Work Order ID 119748

Item Name: Fwd Crosstube - High

DRAWING NO. D212-664-141	TITLE XTUBE ASSY (205/212/412 HI FWD)	REV. D	DART AEROSPACE LTD ENGINEERING ORDER		D.E.O. NO. D212-664-141-D-1	SHEET NO. SHEET 1 OF 2	SCALE NTS
DRAWN	CHECKED	MP	MFG. APPR.	MP	APPROVED	DE APPR.	
DATE 11.04.07	DATE 11.04.11		DATE 11.04.12		DATE 11/04/12	DATE 11.04.12

**PURPOSE:**

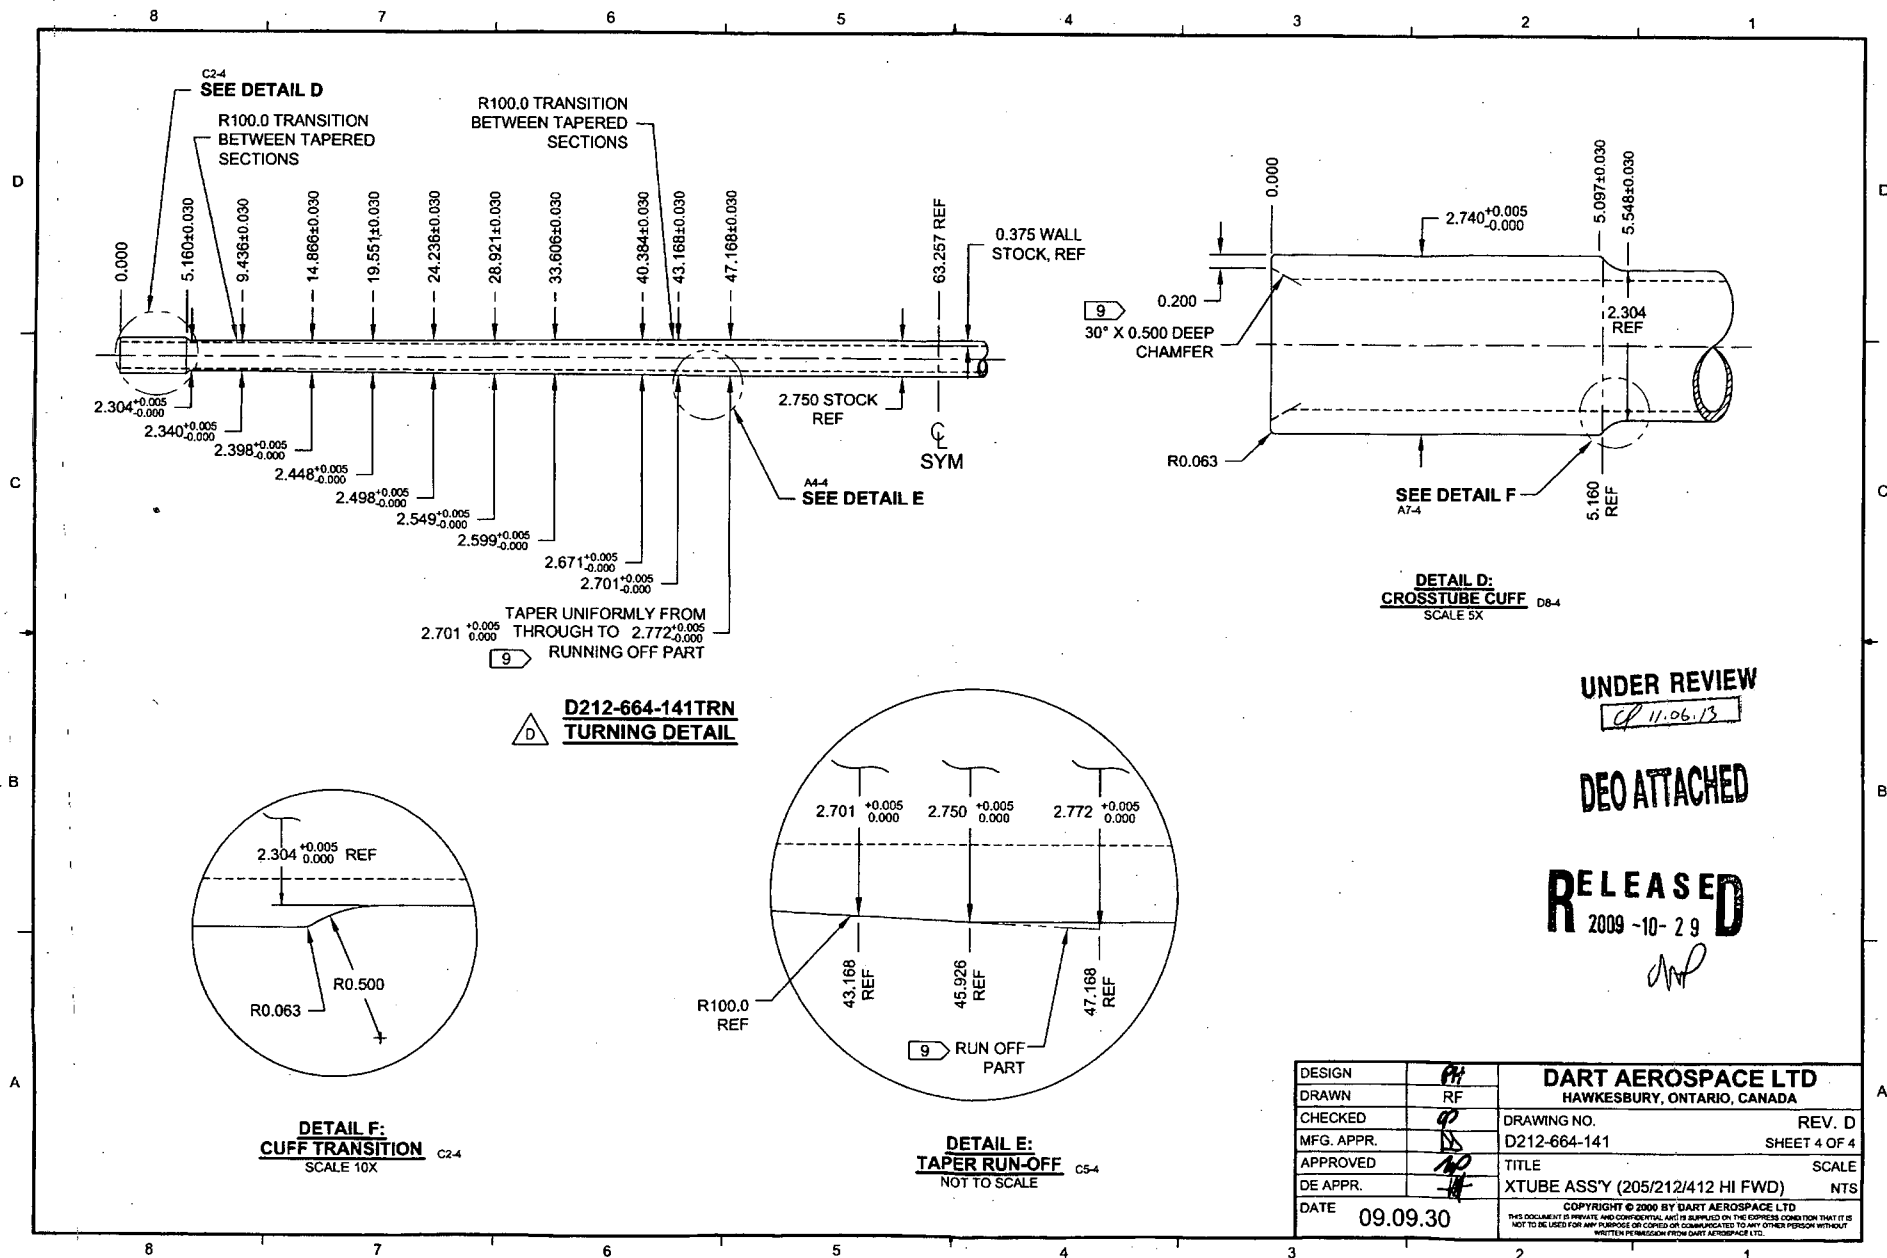
ADD AN INSPECTION WINDOW TO UNDERSIDE OF CROSSTUBE.

- 2) FINISH: CHEMICAL CONVERSION COAT PER DART QSI 005 4.1  
PRIME INSIDE AND OUTSIDE PER DART QSI 005 4.2  
MASK UNDERSIDE OF CROSSTUBE AS SHOWN (HATCHED AREA) AND  
PAINT OUTSIDE PER DART QSI 005 4.2  
REMOVE MASKING AND APPLY CLEAR COAT

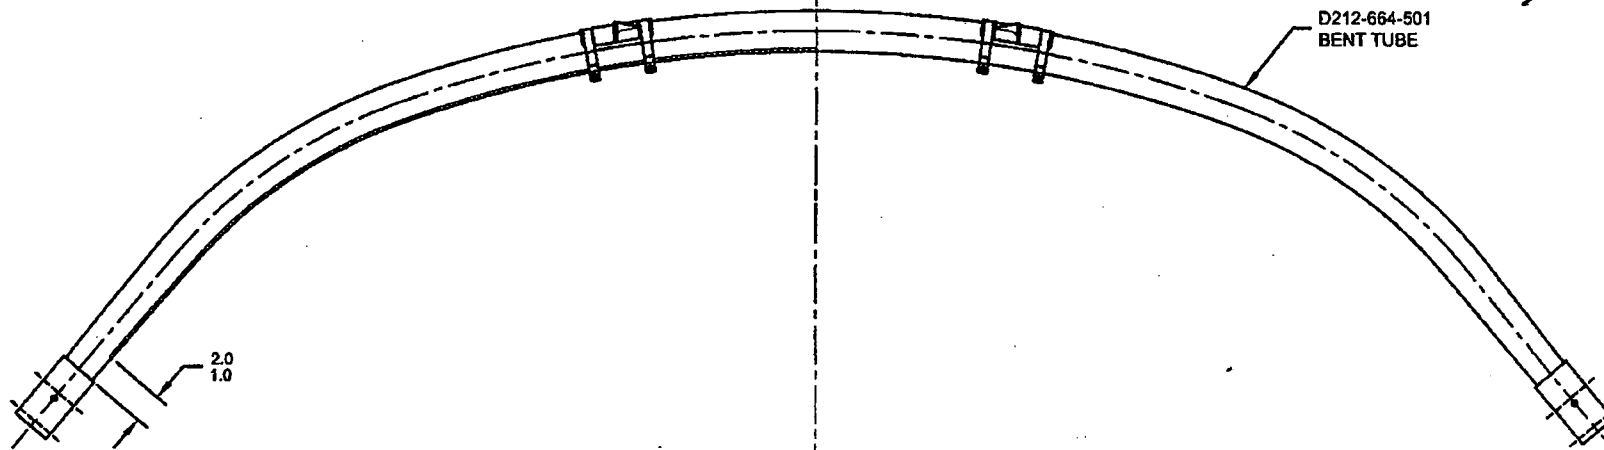
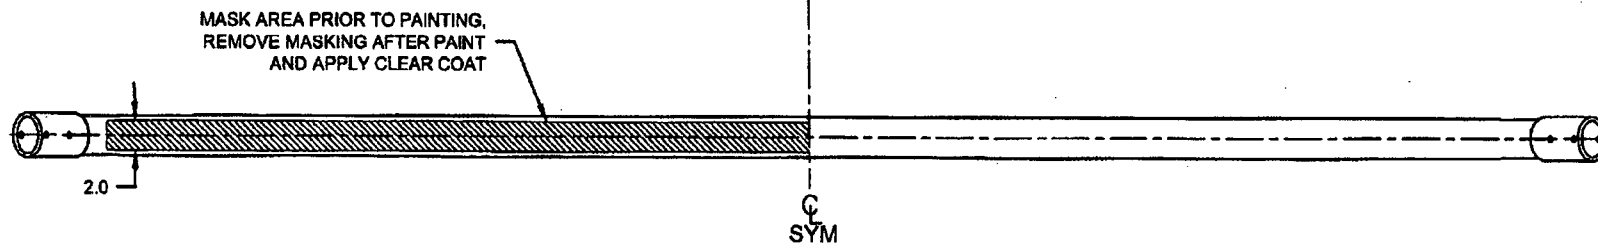
**CHANGE:**

NOTES 2 OF SHEET 1 IS AMENDED AS FOLLOWS:

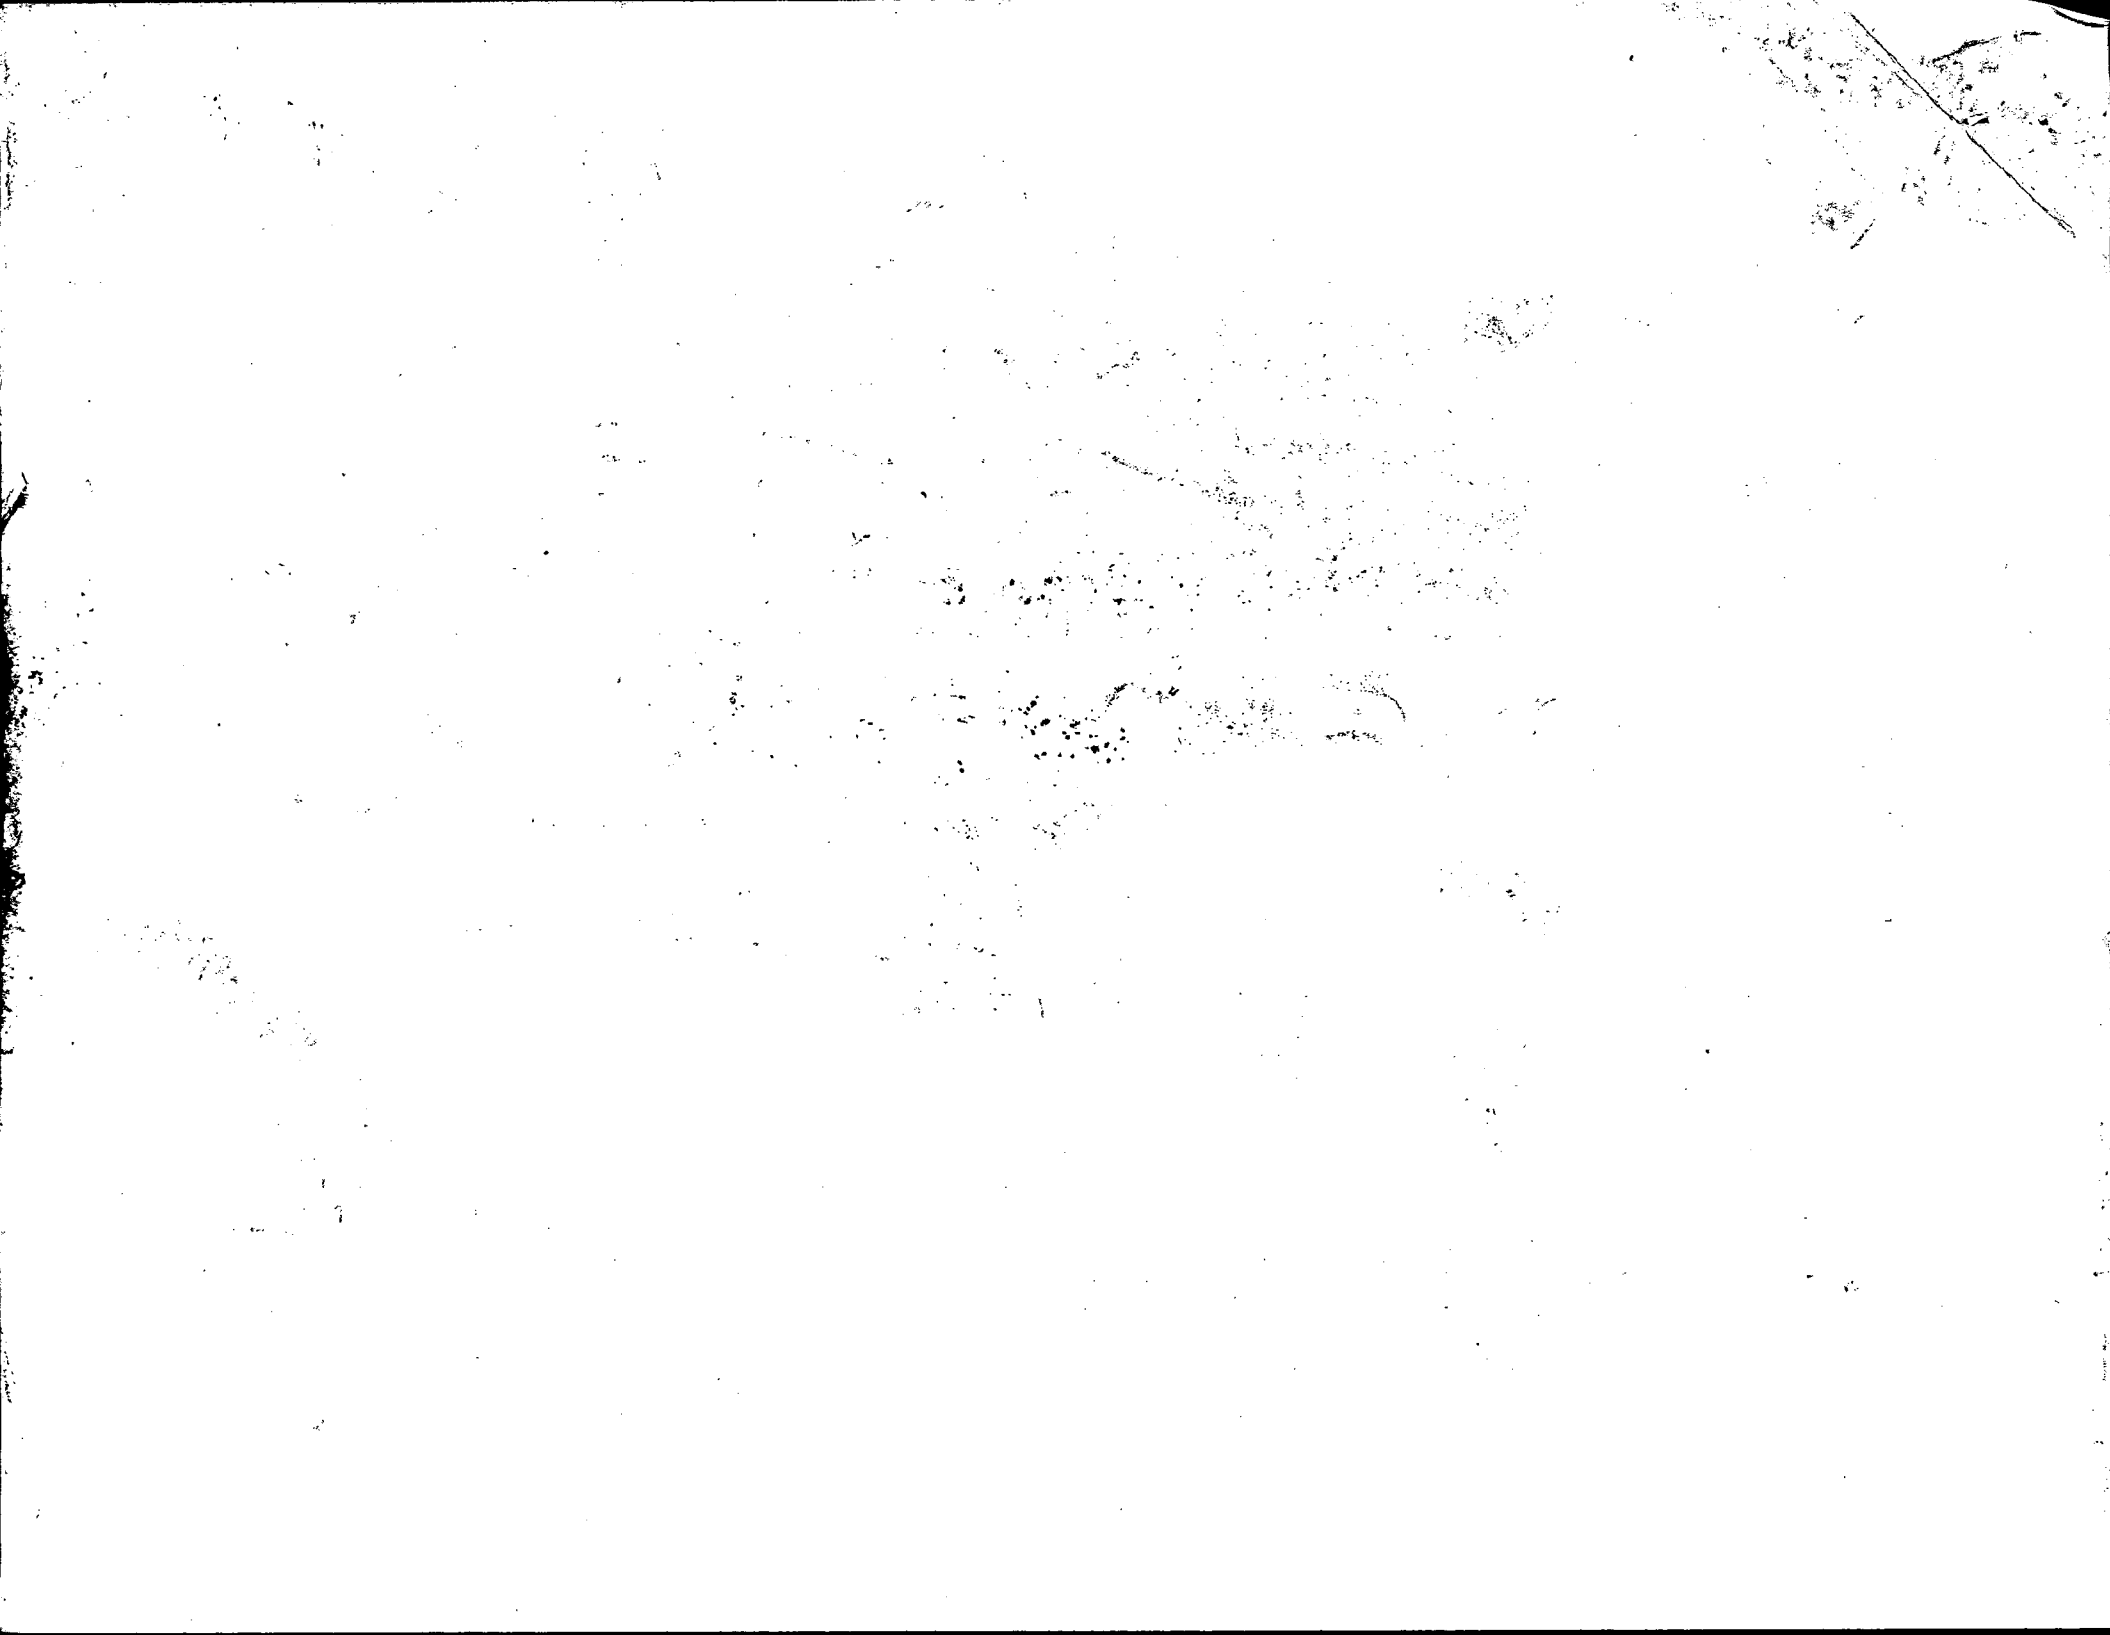
- underbent midde by approx 0.060". was **UNABLE** to reach nominal dimensions. scrapped tube after rebending middle to achieve nominal dimensions. "midde fix after sides are bent" was over effective, it runs from centre line out. therefore. **DO NOT** underbend middles, and use caution if using "middle fix after sides are bent" program. jw 12/6/1

If tube isn't bent enough run 3aaa and up as required to finish. .checking between each program..
